COLORADO DIVISION OF RECLAMATION, MINING AND SAFETY

REQUEST FOR TECHNICAL REVISION (TR) COVER SHEET

File No.: M- 2014-041 Site Name: Macanite 7 and 8

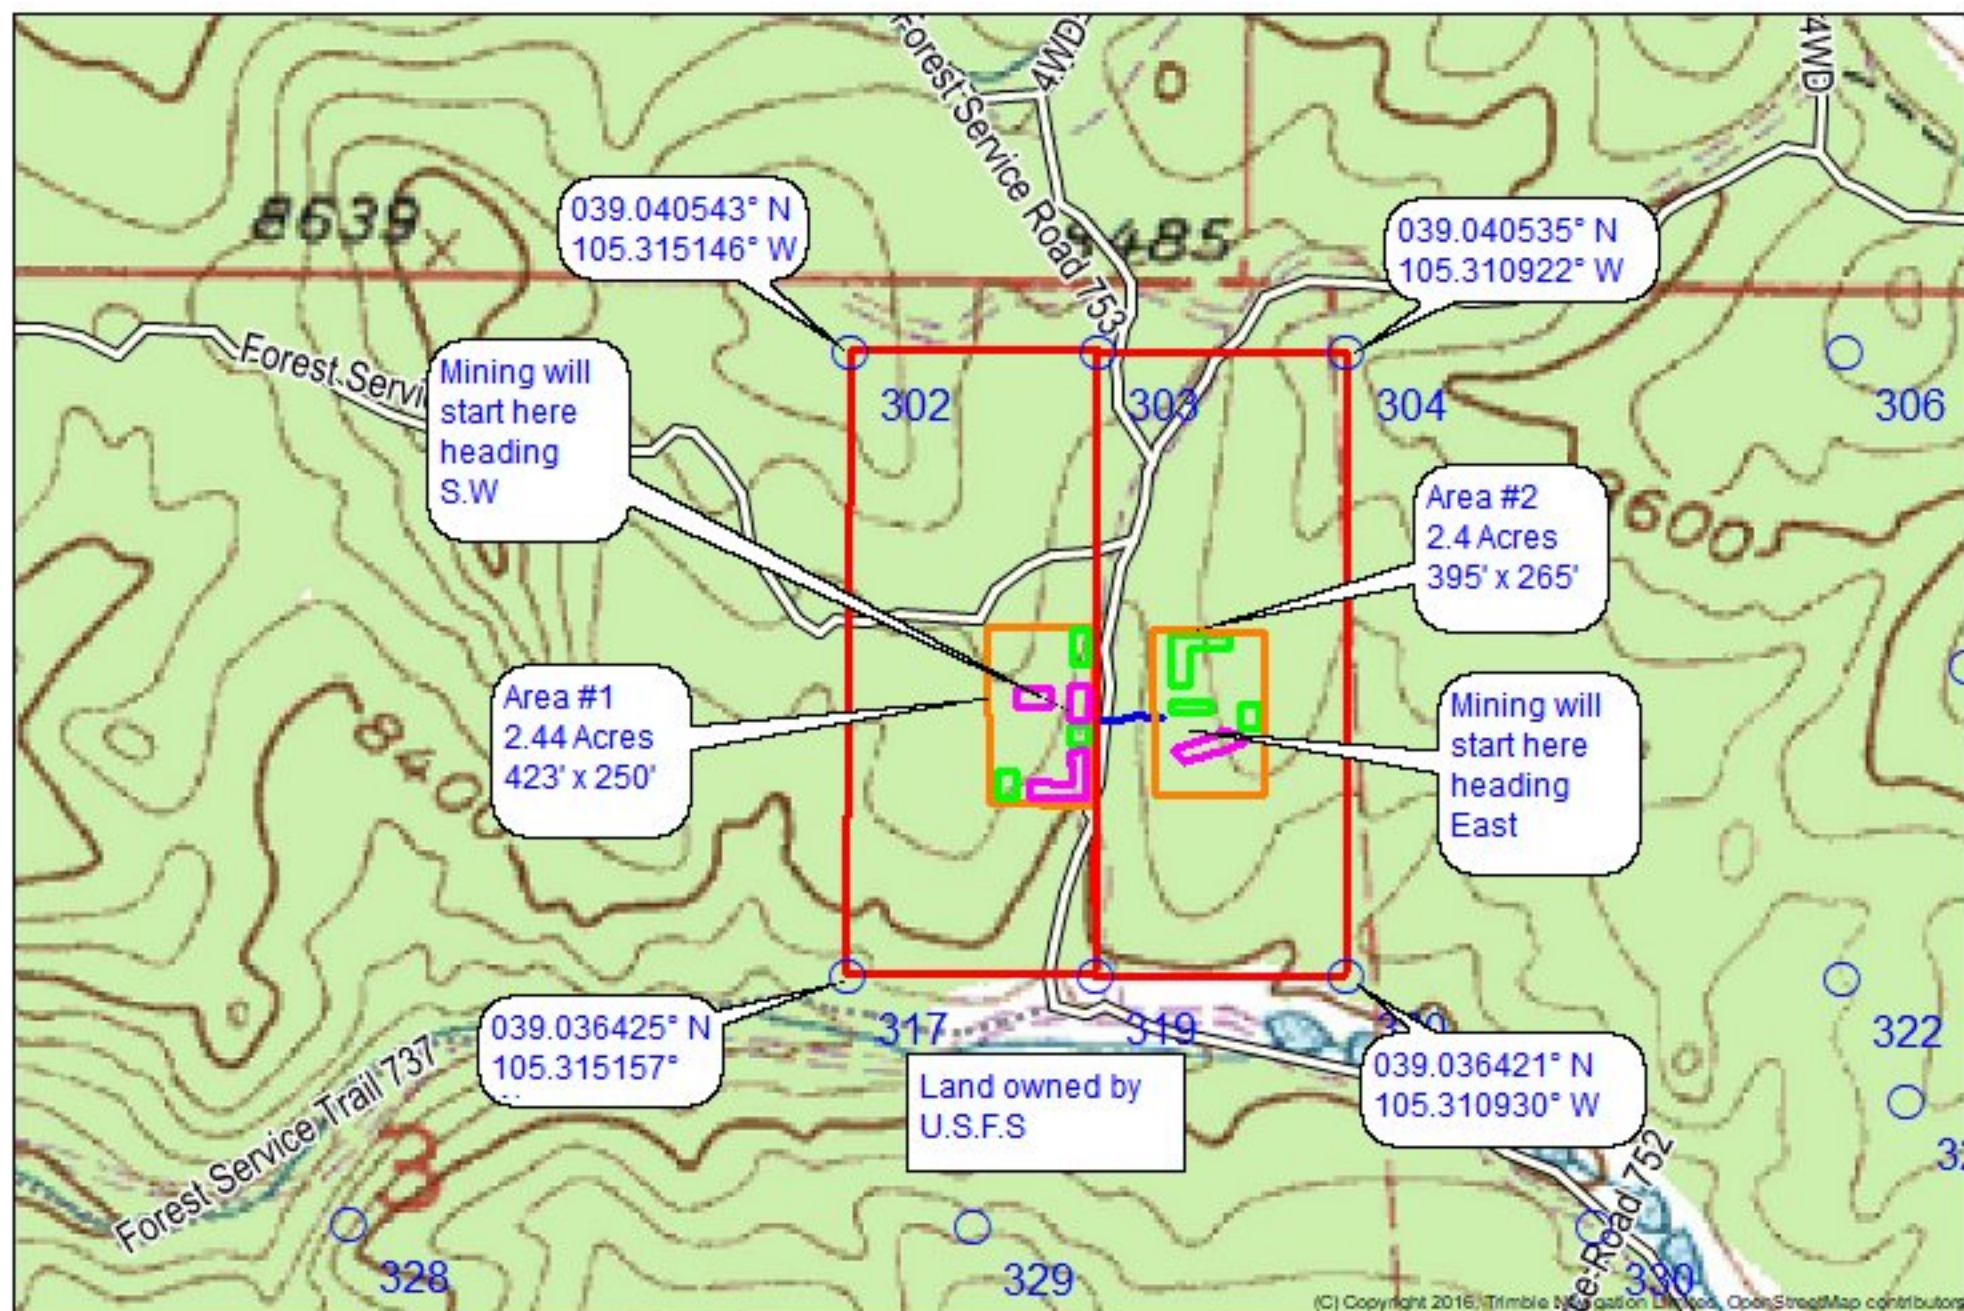
The attached Updated Mine Plan Map and a Reclamation Plan Map are depicting the new location of the 4.9 acre permit boundary. I also want to increase the size of disturbance at any one time within the permit boundary. I will commit to having no more than a total of 1,300 Cubic Yards of material needing to be backfilled at any one time out of the dig (this puts the open dig at slightly smaller than 30x60x20) and also commit to a total disturbance at any one time needing to be seeded at 1 acre.

Additionally, I would like to increase the maximum depth to no deeper than 20 feet. I'm committing that a 20' deep dig will come no closer than 60' from your permit boundary to be protective of off-site lands by maintaining a 3H:1V offset.
